**BROWARD HEALTH****BHCS WOMEN'S CENTER RENOVATION****REQUEST FOR QUOTE****ADDENDUM NUMBER: ONE (1)****DECEMBER 15, 2017**

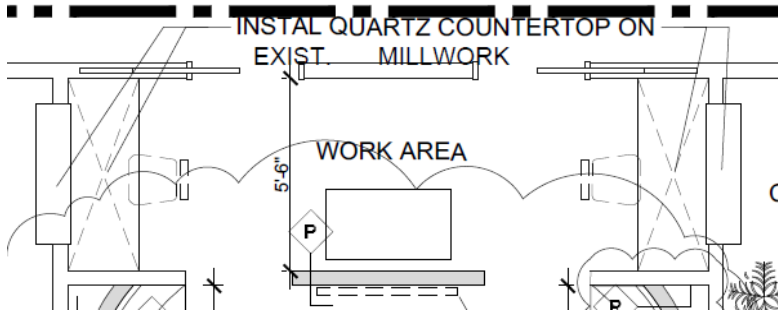
43. In Drawing A1.01 in the location shown in graphic below Demo Legend Note 7 calls for removing all existing cabinets and millwork.

In Drawing A2.01 Note shown in graphic below indicates to install Quarts Countertop on existing millwork in same location above mentioned. Please clarify which indication is to prevail. **Follow note in sheet A2.01**
